**1958 Agreement – Consideration of draft amendments
to existing Regulations submitted by GRE**

Proposal for Supplement 16 to the 02 series of amendments to Regulation No. 3 (Retro-reflecting devices)

Submitted by the Working Party on Lighting and Light-Signalling*

"Figure 1
Marking for single lamps

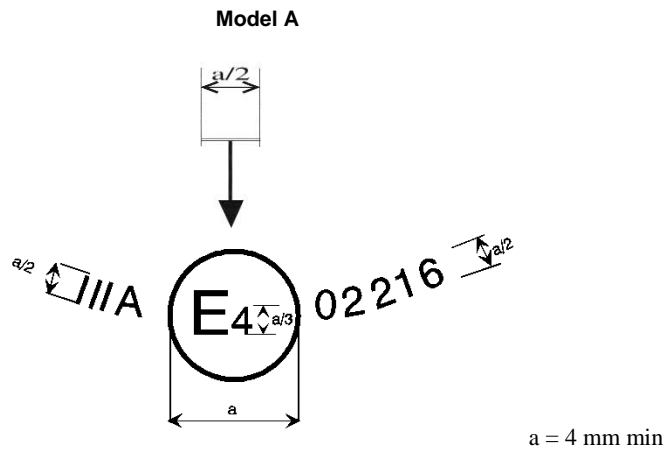
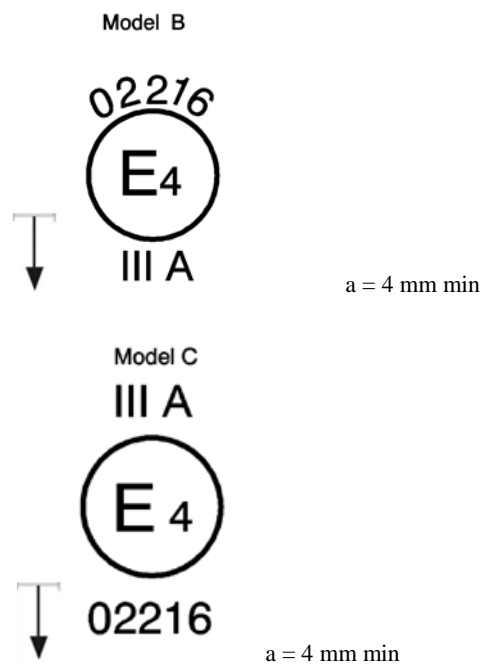
Annex 3, figure 1., amend to read:

The vertical arrow starting from a horizontal segment and directed downwards indicates a permissible mounting height of equal to or less than 750 mm from the ground for this device and can be placed either above or below the circle surrounding the letter "E" or at its side, close to the group of symbols indicating the class or the digits constituting the approval number.
